2.3 Radiation Monitoring Systems

The information in this section of the ABWR DCD, including all subsections, tables, and figures, is incorporated by reference with the following departures.

STD DEP T1 2.3-1 (Figure 2.3.1)

STD DEP T1 2.14-1 (Table 2.3.3)

Figure 2.3.1 Process Radiation Monitoring System Control Interface Diagram

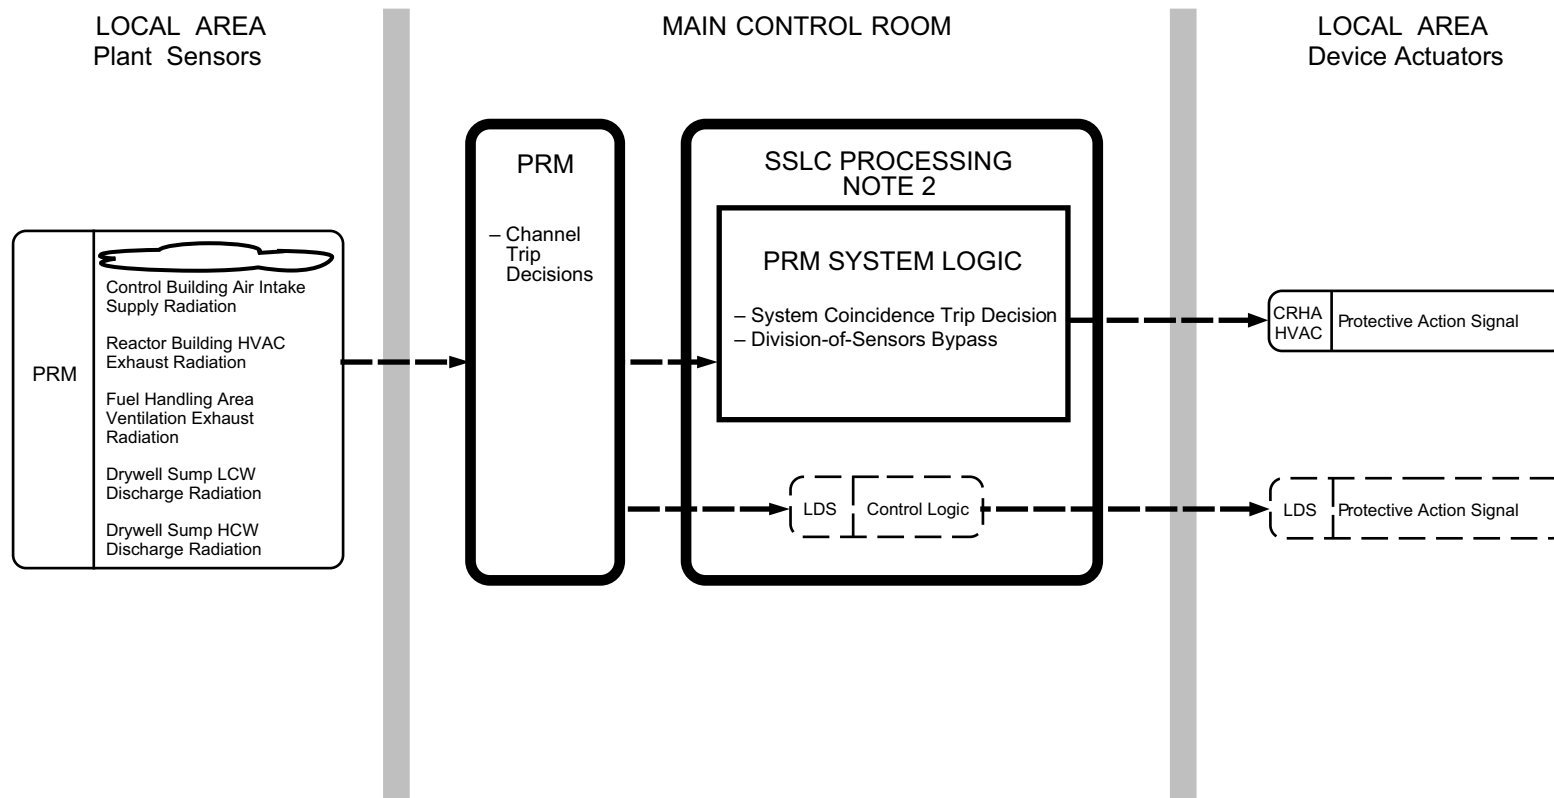
STD DEP T1 2.3-1

Portions of the PRM System are classified as Class 1E safety-related (items 42 through 5 below); the remainder are classified as non-safety-related.

1. Diagram represents one of four PRM System divisions.
2. See Section 3.4, Figure 3.4b for SSLC processing.
